PETITION FOR MODIFICATION

**SOLAR ENERGY GENERATING SYSTEMS (SEGS)
VIII AND IX**

(88-AFC-01C AND 89-AFC-01C)

BATTERY ENERGY STORAGE SYSTEM

FIGURE 1

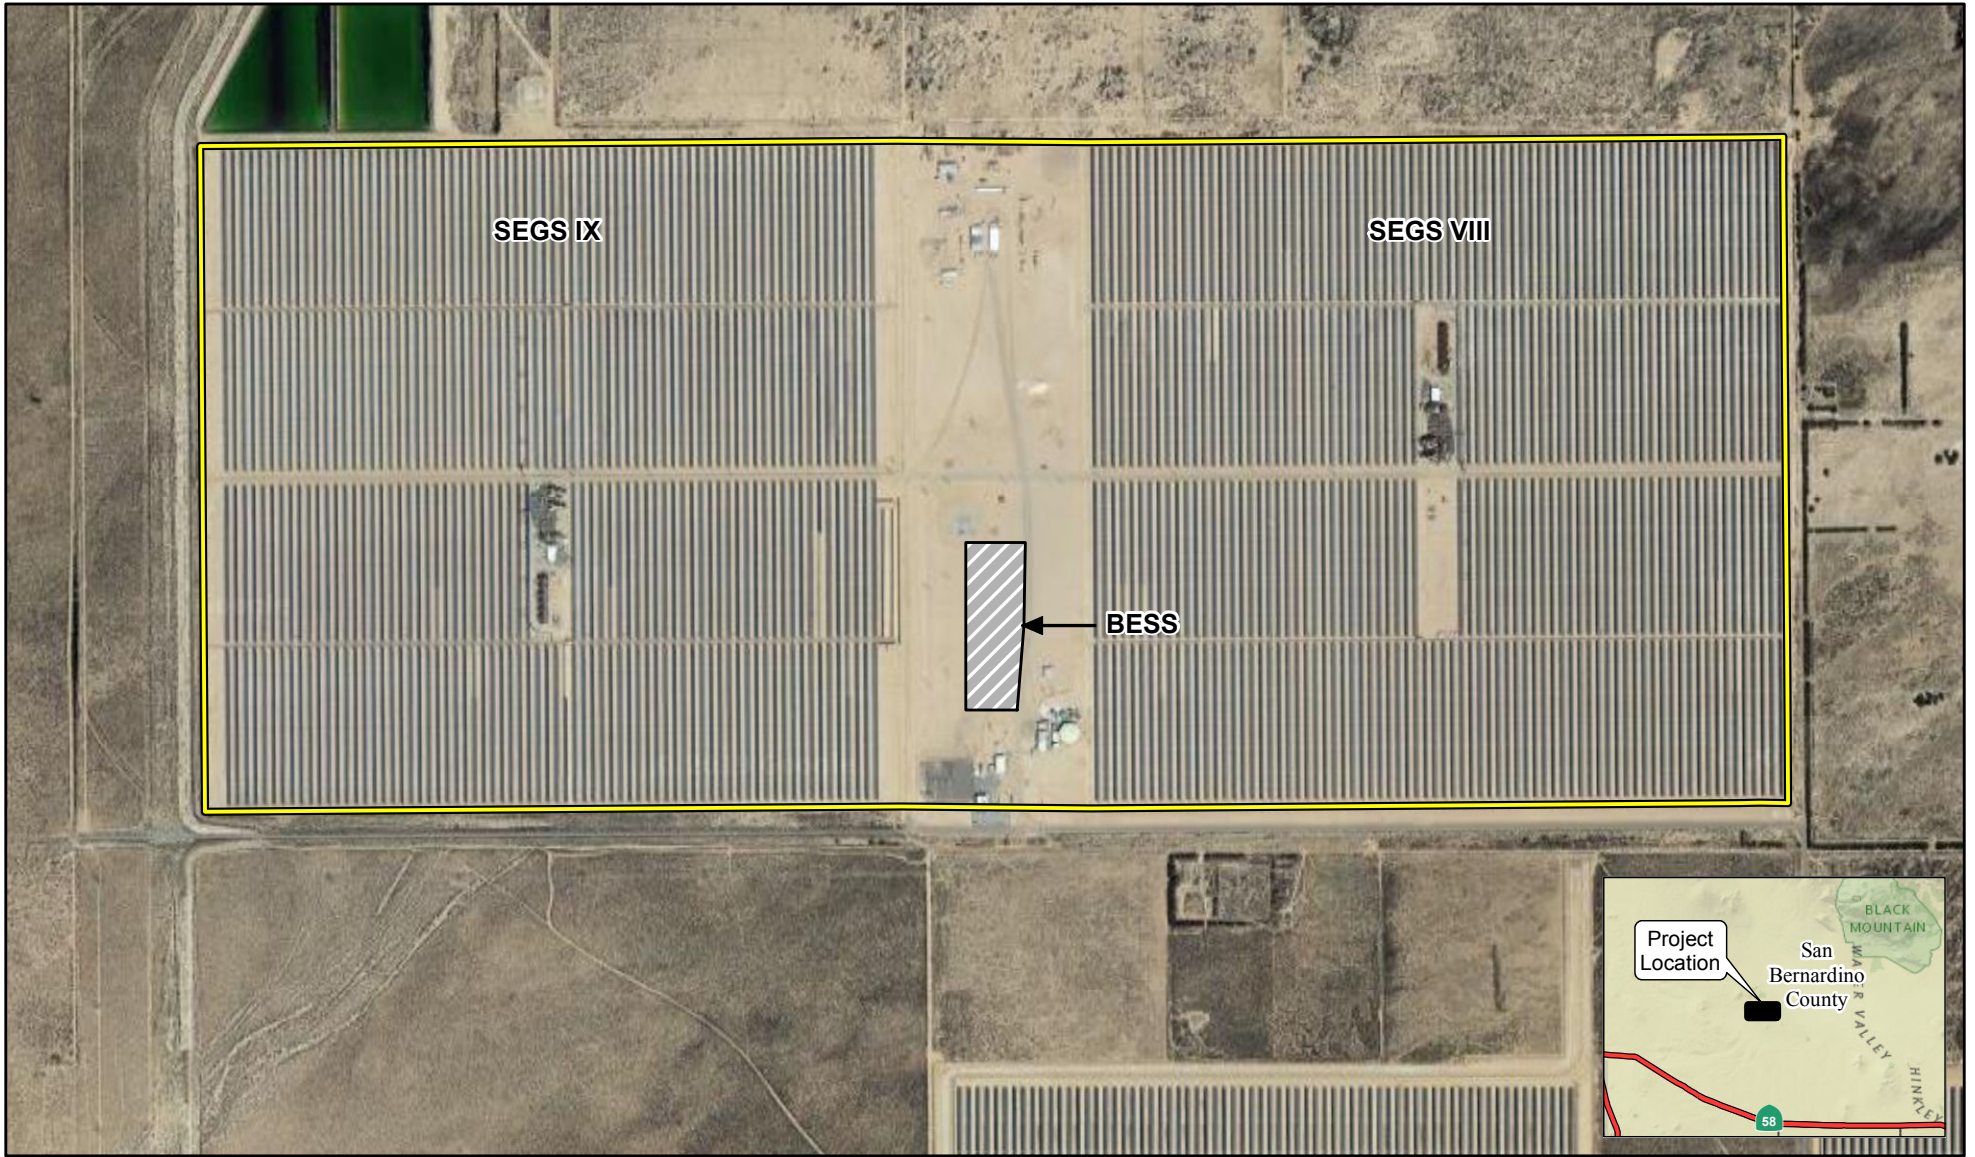
The BESS will be installed on previously disturbed land within the existing footprint of the operating SEGS VIII and IX project, as shown on Figure 1. The total project area for the BESS within the project footprint is approximately 9 acres, with approximately 3 acres of total area occupied with BESS components. The BESS foundations would occupy less than one acre within the reserved footprint.
